DEVELOPMENT REVIEW BOARD REPORT

Hyatt Crossroads 49-DR-2018

Approval of the site plan, landscape plan, and building elevations for a new hotel with 232 guest rooms in a 9-story-tall building, with approximately 130,000 square feet of building area, and a 2-story-tall parking structure, all on a 2.44-acre site.

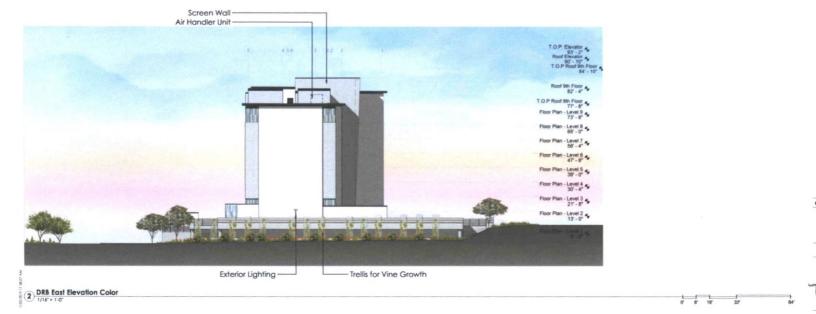
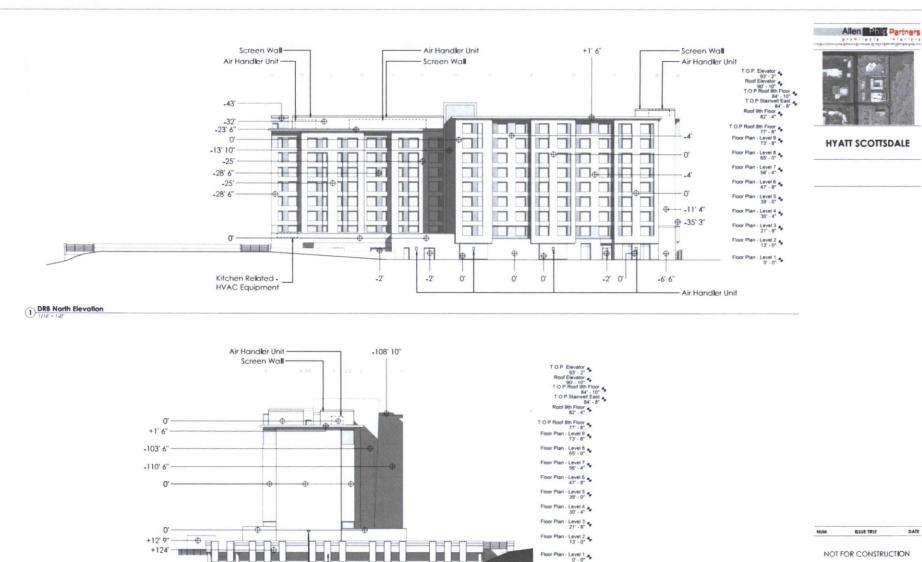
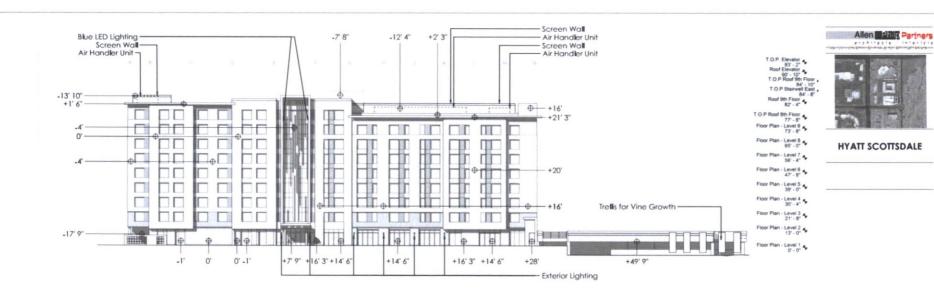
The proposed building design utilizes stucco, insulated glass and metal accents to create a contemporary appearance. Horizontal and vertical planer differentiation creates visual interest and depth on the north and south elevations; however, the east and west elevations of the building consist of largely blank walls that, apart from ribbed metal accents, lack visual interest. The "Architectural Details, Materials and Colors" section of the Commercial Design Guidelines emphasize the need for all sides of a building to "express consistent architectural detail and character". The addition of windows or other architectural variations similar to those on the north and south elevations are recommended. Contrary to the City's Sensitive Design Principle #9, the design utilizes pastel colors that are not representative of the surrounding southwest desert context. Additionally, windows on the elevations most exposed to sunlight are reliant on insulated glazing to prevent solar heat gain, rather than physical devices that provide shading and shadow.

- 4. Prior to the final plans submittal, the applicant shall coordinate with Current Planning staff to add visual interest, in the form of windows or other architectural variations, to the east and west elevations of the hotel building.
